The Center for
Environmental Law & Policy

Re: Odessa Subarea Special Study Scoping Comments

CELP scoping comments on Odessa Subarea Special Study
September 19, 2008

A Review of “The Economic Impact of a Possible Irrigation-Water Shortage in Odessa Sub-Basin: Potato Production and Processing”, Sanjoy Bhattacharjee and David Holland, School of Economic Sciences, Washington State University, June 6, 2005.

Figure 1: Location of the Odessa Area Groundwater Irrigated Lands
 (Source: http://www.usbr.gov/pn/programs/ucao_misc/odessa/report-alternatives.pdf)

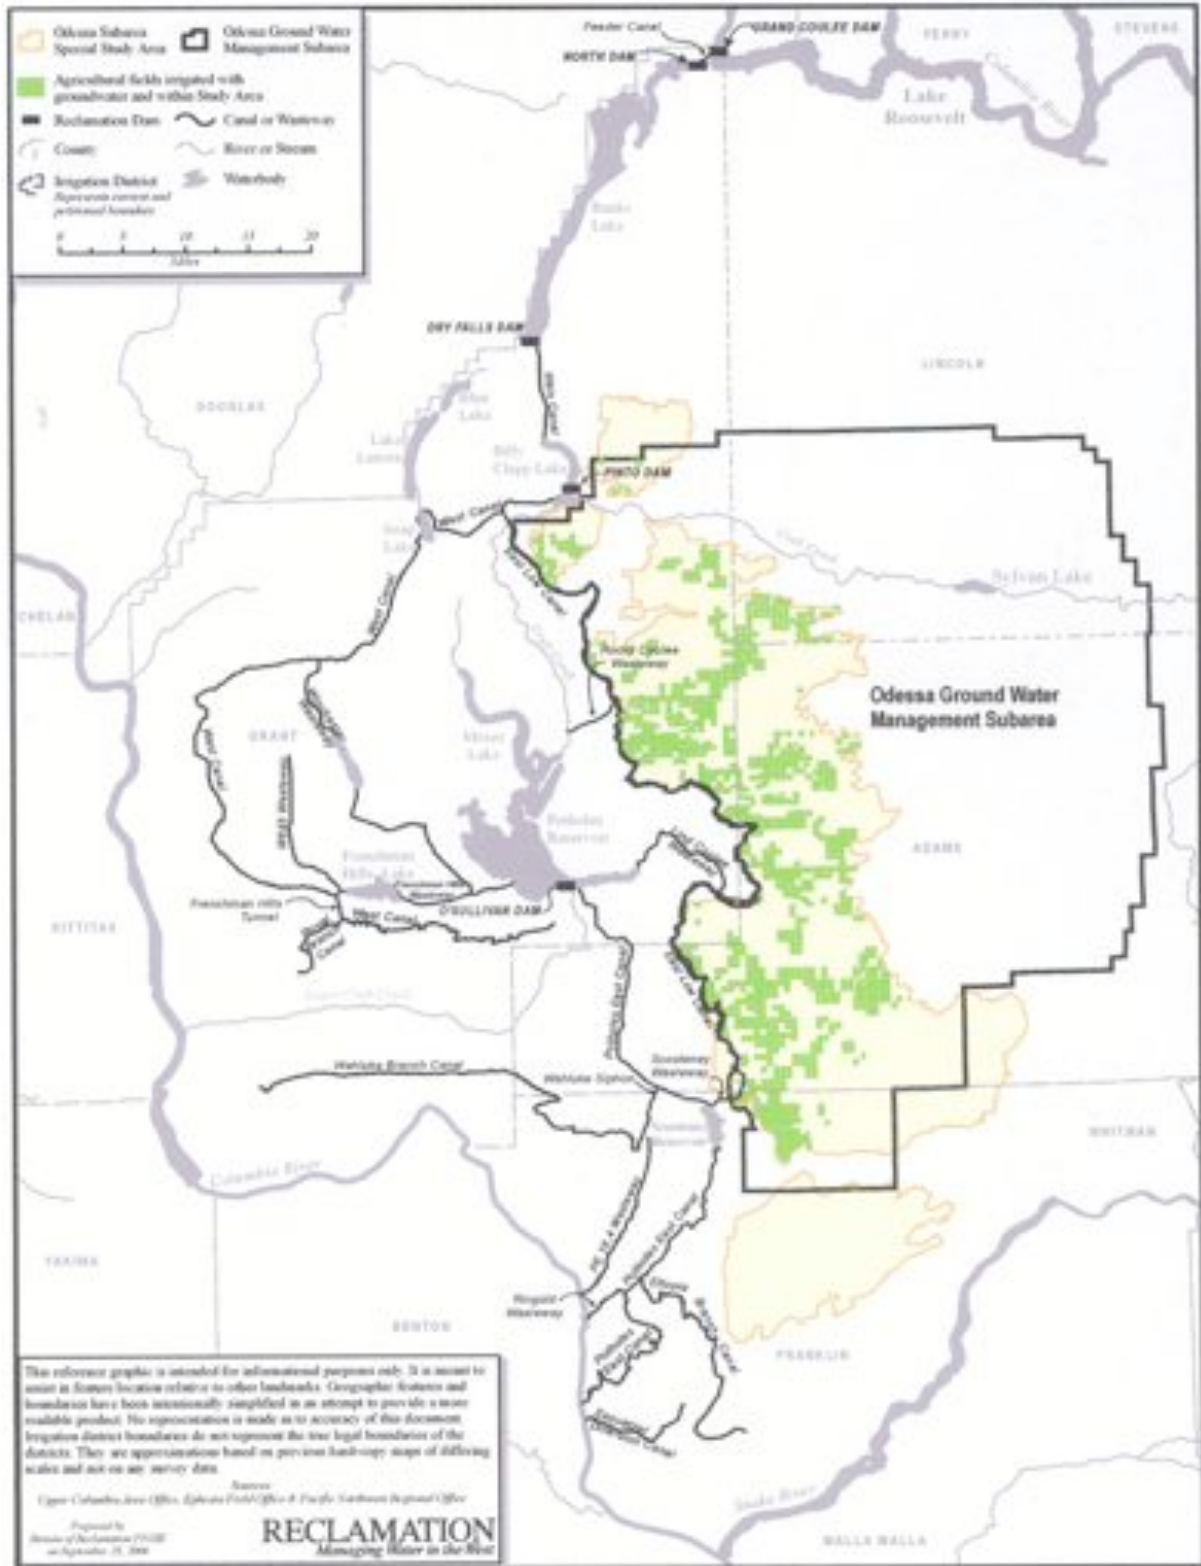
There are several other mismatches between the B-H study and the proposal to provide Columbia Basin Project water to the Odessa area groundwater users. There are 170,000 groundwater irrigated acres in the Odessa area (the green areas in figure 1). However, the alternatives addressed in the BOR studies propose to provide water to only 40,700 to 140,000 acres of this land, presumably leaving 30,000 to 129,300 acres to go dry.
